## MVHC-200/300 Series Top Cover Exterior Change Notification

MVHC-200/300 Series

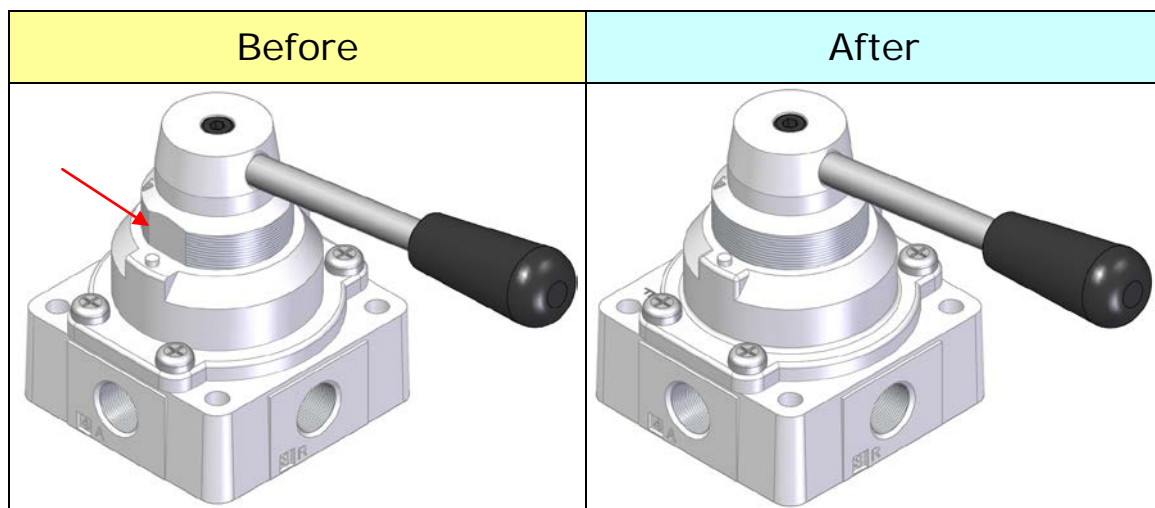
To promote the benefit of molding, we cancel the design of plane on the thread of the top cover.

Variation of Top cover exterior
